39.03.41 – RULES GOVERNING TRAFFIC CONTROL DEVICES

001. ~~TITLE AND SCOPE~~ **PURPOSE.**

The “Manual on Uniform Traffic Control Devices for Streets and Highways” is published by the Federal Highway Administration of the U.S. Department of Transportation. The ~~2009-11th~~ edition ~~including revisions 1 and 2~~ of the Manual with an effective date of ~~June 13, 2012~~ **January 18, 2024**, is hereby incorporated by reference and made a part of the Rules of the Idaho Transportation Department. The following conforming additions to the Manual are adopted by the Idaho Transportation Board: (3-31-22)

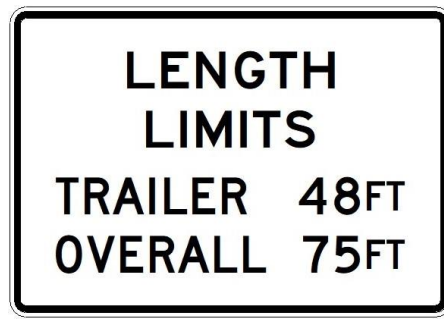
12. Figure 2B-3. Speed Limit Signs and Plaques. On page 86, delete signs R2-2aP, R2-2bP, R2-2cP, R2-6aP, and R2-10 and add the following sign:

R2-201P

16. Figure 2B-30. Road Closed and Weight Limit Signs. On page 136, change the figure title to “Figure 2B-30. Road Closed, Weight Limit and Trailer Length Limit Signs” and add the following sign:

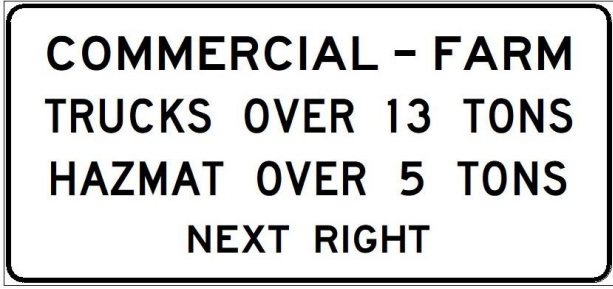
R12-501

07a A TRAILER LENGTH LIMIT (R12-501) sign (see Figure 2B-30) may be used in advance of highways with length restrictions.

Figure 2B-~~34~~³². Chains Required On Non-Exempt Commercial Vehicles Sign

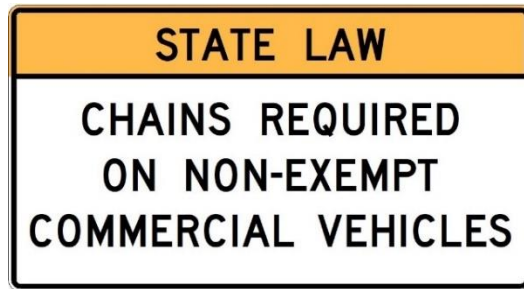
~~09. Section 2B.70**69a**, CHAINS REQUIRED ON NON-EXEMPT COMMERCIAL VEHICLES (R16-201) sign. On page 102, add the following section:~~

~~01 **When required by state law**, CHAINS REQUIRED ON NON-EXEMPT COMMERCIAL VEHICLES (R16-201) signs (see Figure 2B-34) shall be installed ~~when mountain passes are determined to be unsafe by the Idaho Transportation Department~~. **If used,** ~~two~~ **two** or more CHAINS REQUIRED ON NON-EXEMPT COMMERCIAL VEHICLES signs shall be installed in advance of an area that has been provided for drivers to pull off of the highway to install chains on their tires (see Section 2L07).~~
